TECHNICAL SERVICE BULLETIN

TSB C-NP-FN-0059

Date: October 4, 20224
To: All Service and Parts Managers
From: Technical Services Department
Subject: **New Flue Elbow for 90+% Upflow Furnaces for Improved Condensation Management**

Figure 1: New Flue Elbow (Part # 0164F00029) for All 90+% Upflow Furnaces

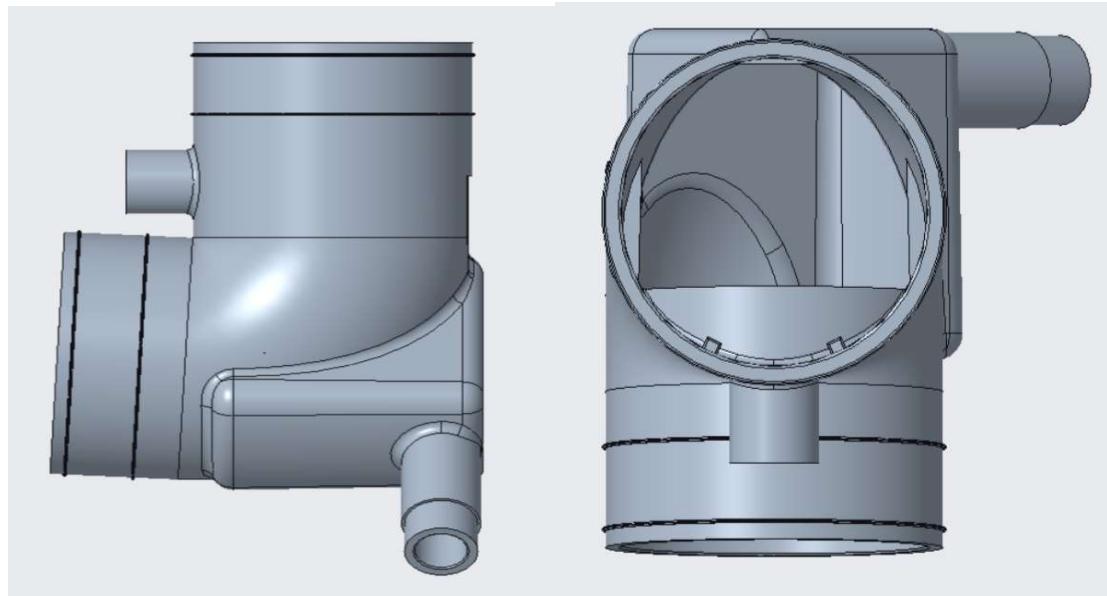
We are pleased to announce a new Flue Elbow (**Part# 0164F00029**) for all 90+% upflow furnaces, as shown in Figure 1 below, that replaces the current Flue Elbow (**Part# 0164F00025**). All 90+% upflow furnaces with a serial number of 2410 or later include the new Flue Elbow. The redesigned Flue Elbow helps manage increased condensation levels with a higher dam near the inducer connection to help block condensate from entering the inducer assembly, compared to the current Flue Elbow.

The diameter of the horizontal left drain port in the bend of the elbow has been increased to the same size as the main drain port making it easier in the field to change to the alternate drain port, compared to the current Flue Elbow. This alternate drain port is closed with a plug from the factory. The new Flue Elbow has an 87° bend at the inducer connection to tilt the elbow down 3° toward the drain port. A stamped extrusion has been added to identify the hose clamp screw location.
